**Subject: Avanzando Development Traffic Impact Study  
Southeast corner of NM 500 and Loris Drive  
Bernalillo County, New Mexico**

This letter is to inform you that the **FINAL** Traffic Impact Study (TIS) for Avanzando Development dated March 20, 2023 has been reviewed. The proposed development is located on southeast quadrant of NM 500 (Rio Bravo Blvd.) and Loris Drive.

# EXHIBIT A

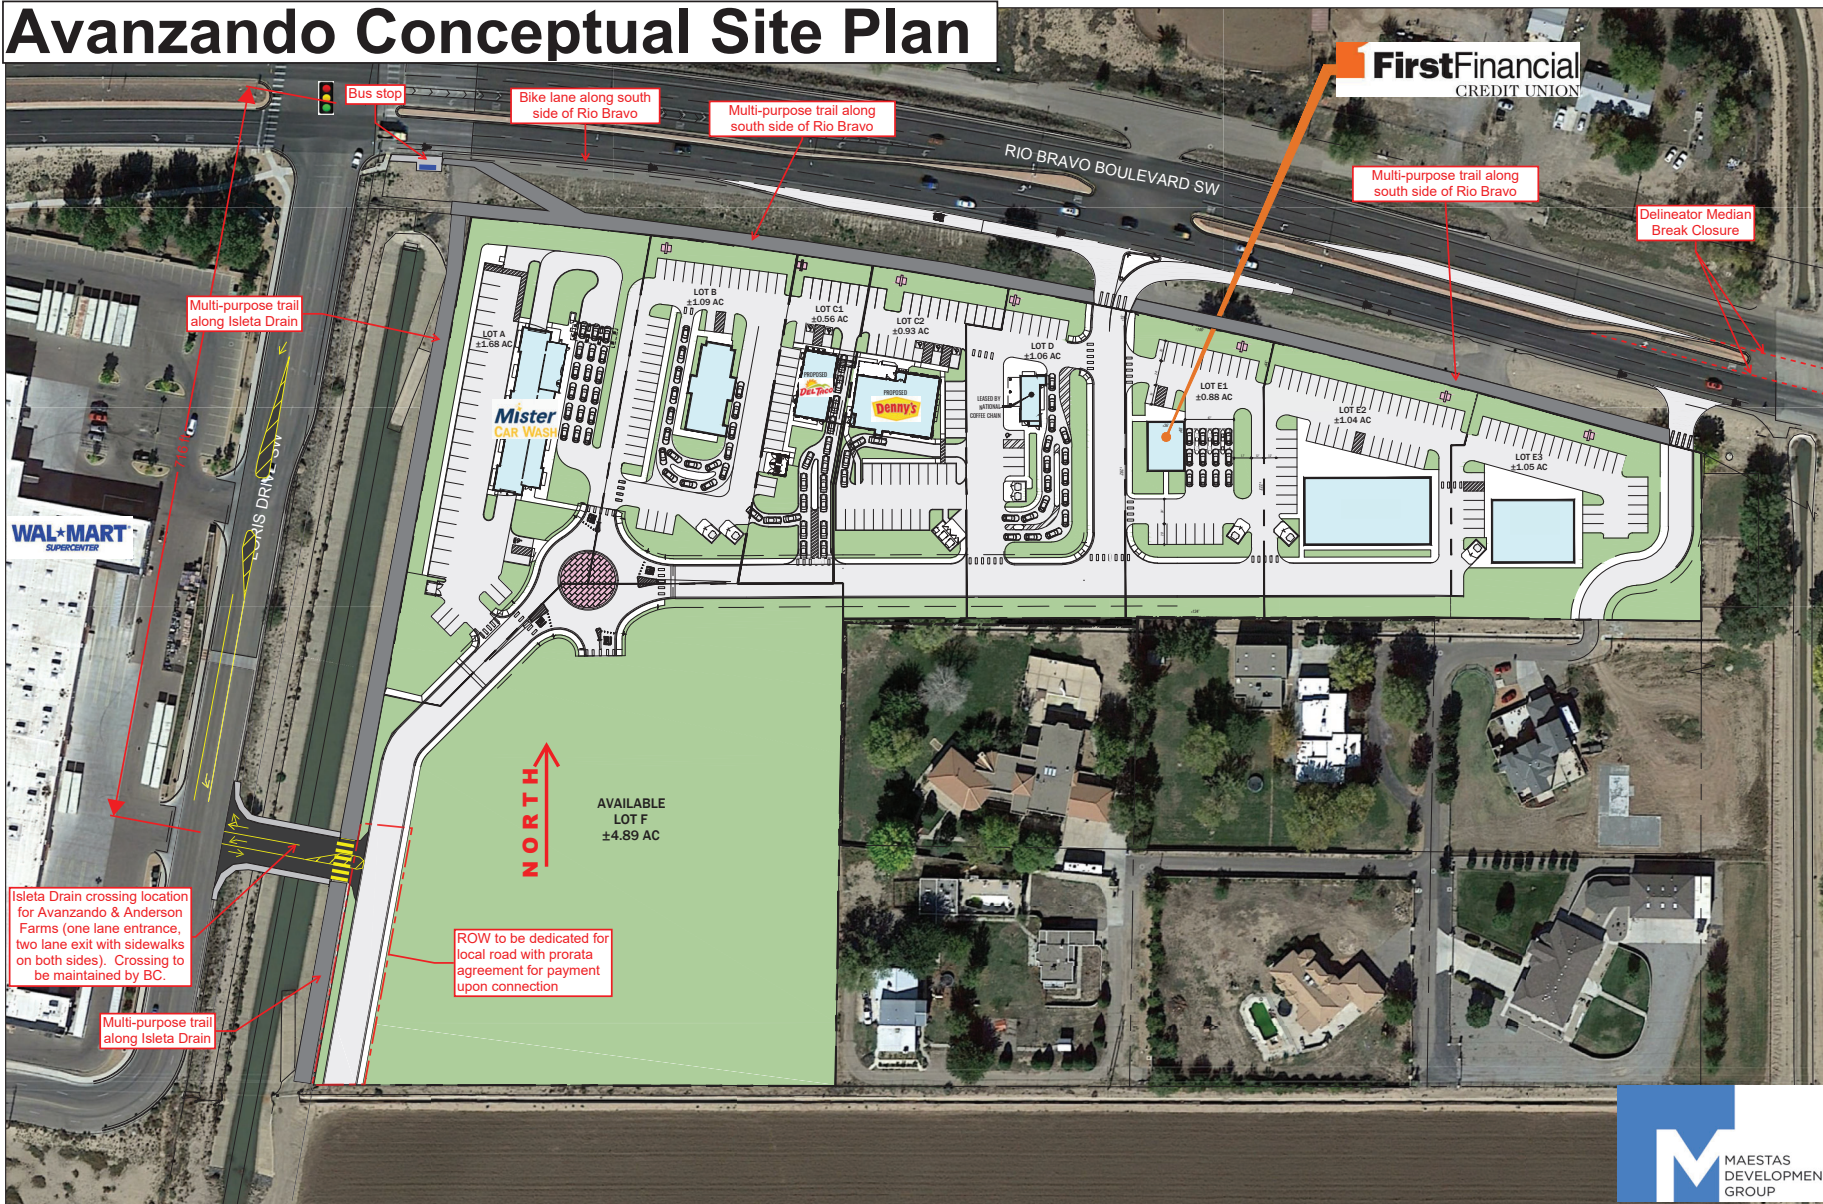
The NMDOT has no objection to one partial access located on NM 500. The partial access will be limited to right-in, right-out and left-in only. See Exhibit A for the access location and site plan. This study provided recommendations to mitigate its impacts, these are summarized in Exhibit B. Based on these analyses, NMDOT concurs on this development with the following conditions:

1. The property owner shall submit a Commercial Driveway Application for one partial access, right-in, right-out, left-in only on NM 500.
2. The development shall install an eastbound right deceleration lane at its access on NM 500 to a total length of 370-feet (220 feet plus 150-foot taper).
3. The development shall extend the existing westbound left deceleration lane at its access on NM 500 to a total length of 420-feet (270-feet plus 150-foot taper).
4. The development shall install median islands at the Avanzando Driveway to prevent a left-out egress movement.
5. The development shall install delineators across the median access for the Arenal Drain.
